Australian Energy Market Operator
GPO Box 2008
Melbourne
VIC 3001
(Lodged electronically via 2020PSFRR@aemo.com.au)

11 December 2020

AEMO Power System Frequency Risk Review – Stage 2 Draft Report

ATTACHMENT 1 – Comparison of Callide Unit trips pre and post-Mandatory PFR

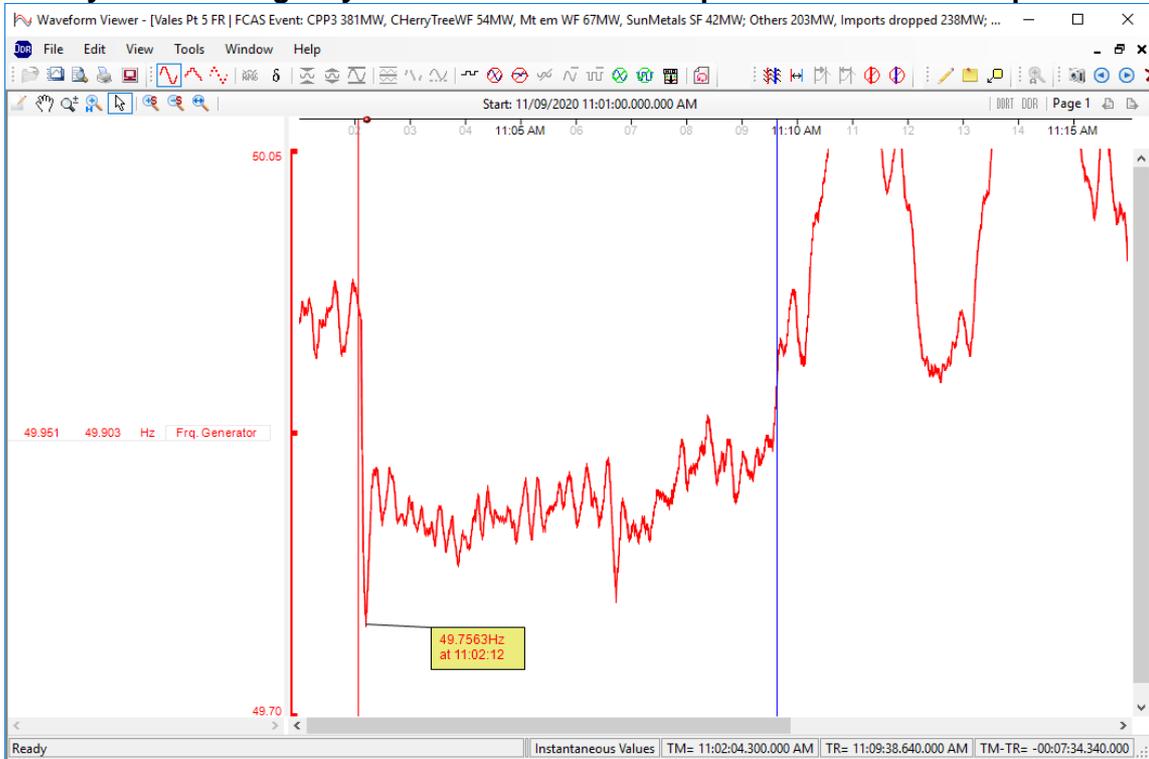
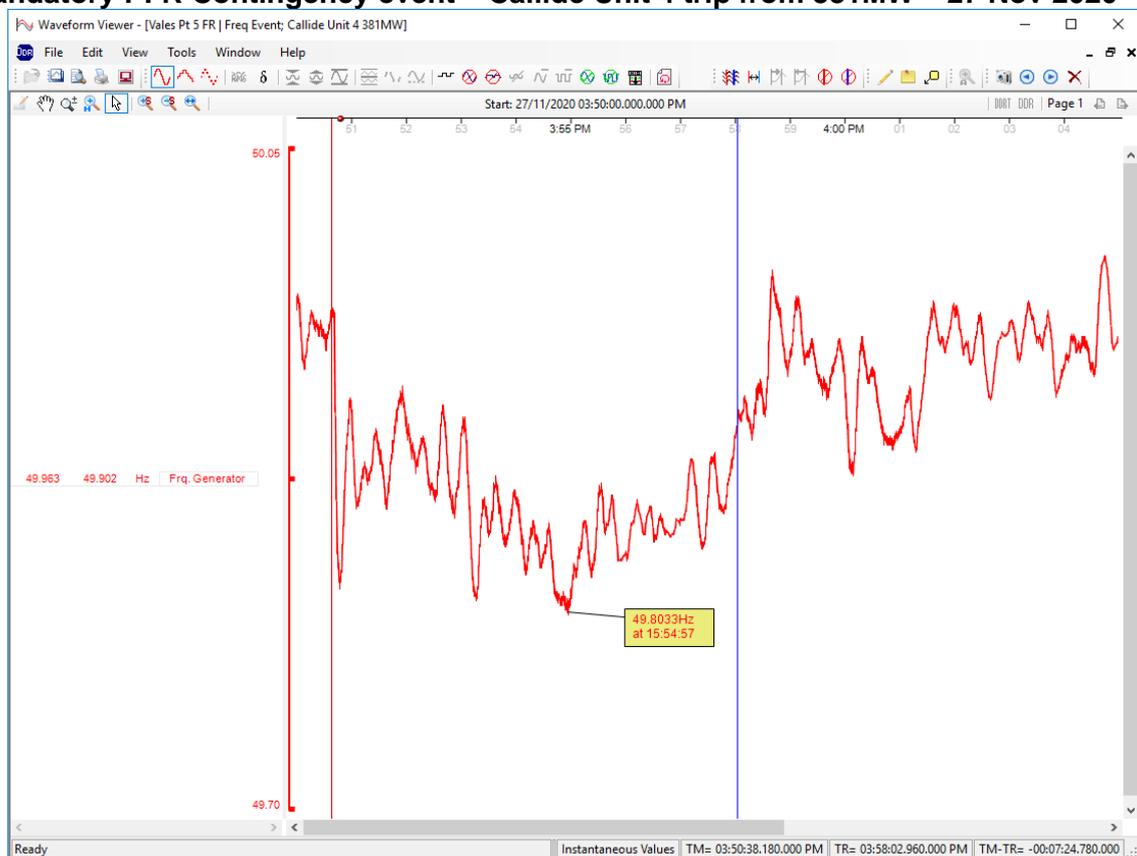
- Pre-"mandatory PFR" Rules should not be considered in anyway similar to no PFR because PFR was still in existence and delivered but due to the adoption of and adherence to AEMO Market Ancillary Services Specification designs and Rules for Frequency Control Ancillary Services in the implemented designs of the frequency controllers of Units, at many installations PFR delivery was set for wider deadbands than that now mandated. Many participants whilst having PFR incorporated into FCAS controllers, meaning the control and some of the PFR could be deselected when the Unit was not enabled for FCAS, did not disable the controllers even when not dispatched to provide contingency FCAS. As many participants still have mechanical-hydraulic governors backed up by stored energy, a lot of very fast PFR remained in the system at the deadbands now mandated.

It is suggested that AEMO think carefully of how the report may be misinterpreted by others, including those within governments and AEMO itself as implying that Mandatory PFR is the only option worth considering in the NEM post 2023 when the mandatory PFR Rules may expire. The amount of Mandatory PFR already engaged has had a marked impact on comparisons of frequency performance measured against the current frequency operating standards. See Attachments 1 and 3. Why doesn't the Frequency Risk Review also balance off the market examinations that the "market" operator ought to also be concerned about and cover the risks that mandatory Rules are obtaining too much PFR impacting potentially on market efficiency?

ATTACHMENT 2 – Trends of NEM Frequency Event Counts outside NOFB – Jan 2012 to Nov 2020

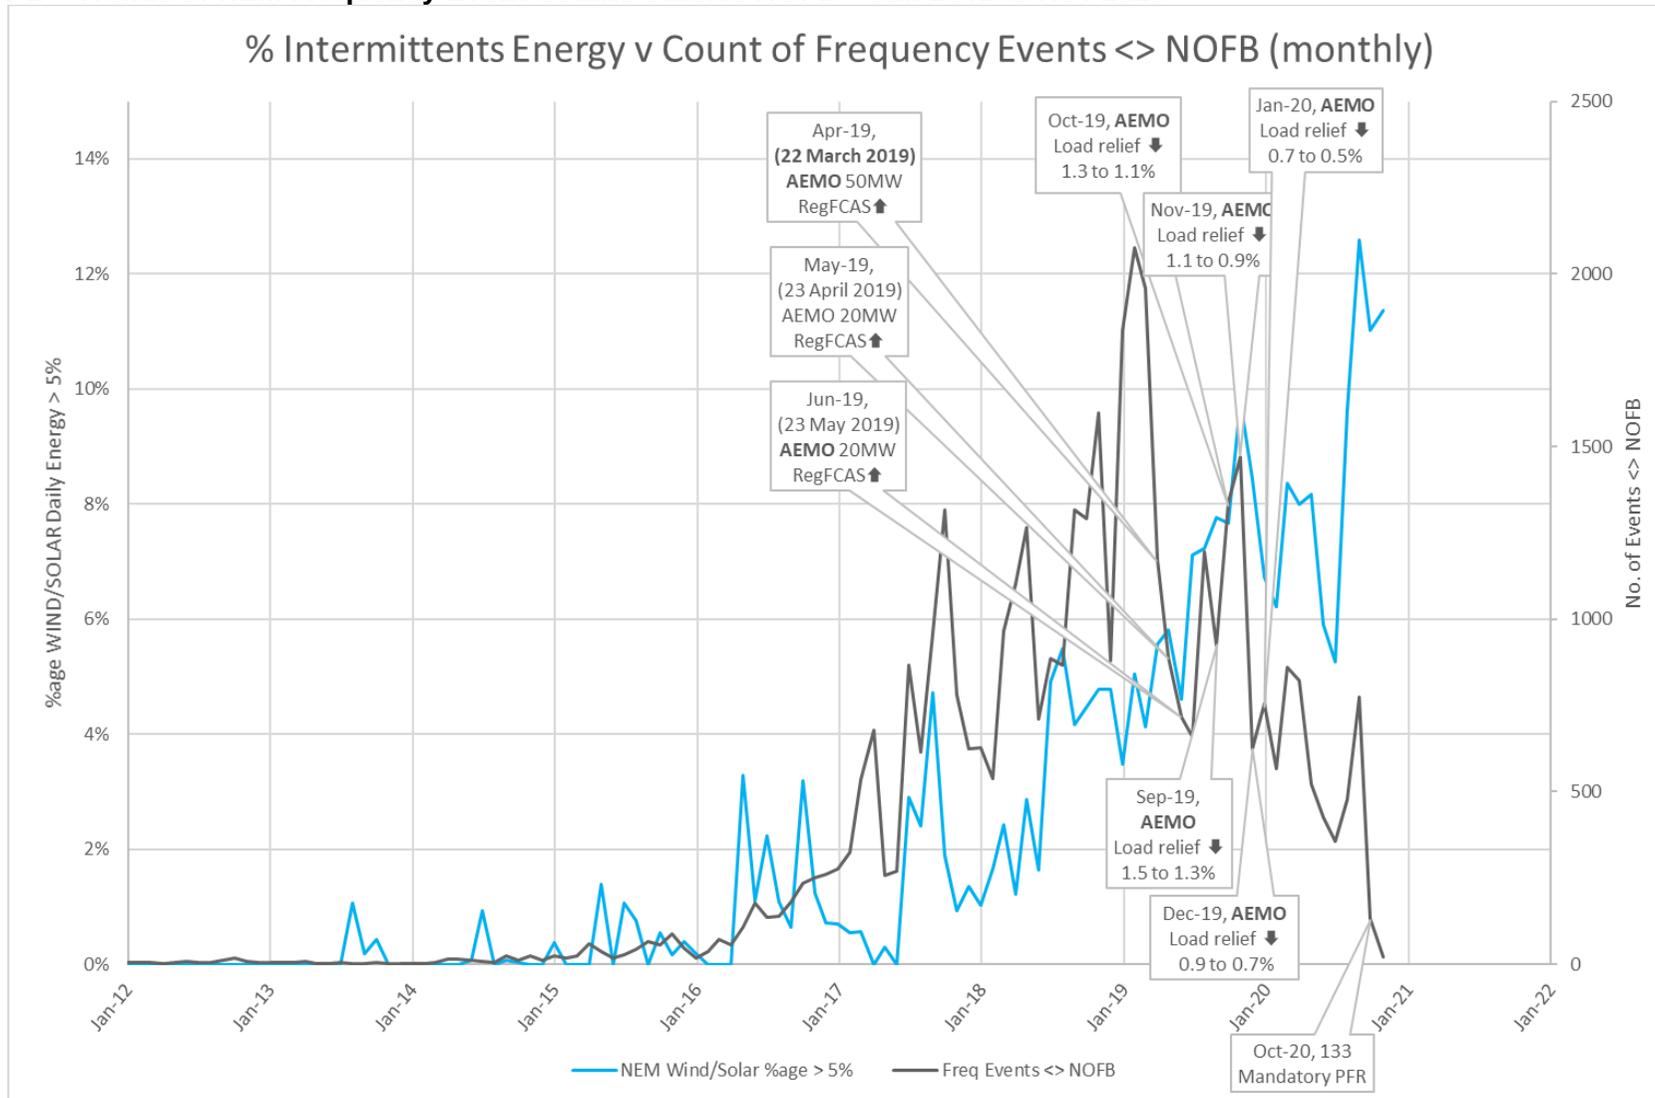
The Frequency Risk Review may also benefit from considering the other quality issues for frequency that have emerged that also could represent a future risk to the NEM. One such risk relates to the unsteadiness of the frequency within the coordinated collective controls of governors, Unit controllers, AEMOs AGC and market systems. The transition towards and growth of inverter technology may be having consequences not yet examined in the report because of its present need to keep its focus on “non-credible” power system contingency events. The attachment 2 displays charts from Delta and AEMOs own reports of the present histogram distribution of frequency and shows that since the commencement of first tranche delivery of Mandatory PFR, a large divergence either side of the nominal 50Hz state has occurred. Whether this is due to the lack of coordination between governor deadbands, deadbands of secondary Unit controllers and AEMO Regulation FCAS delivery is not known but the risk perhaps warrant being drawn out and explored. Perhaps the deadbands assigned by Mandatory PFR Rules and AEMOs IPFRR are too tight? Are the frequency traces in attachment 1 representative of the more volatile frequency reactions that occur since mandatory PFR? Delta Electricity therefore considers that a risk to be examined by AEMO should include that arising from a lack of coordination in the overall control of frequency.
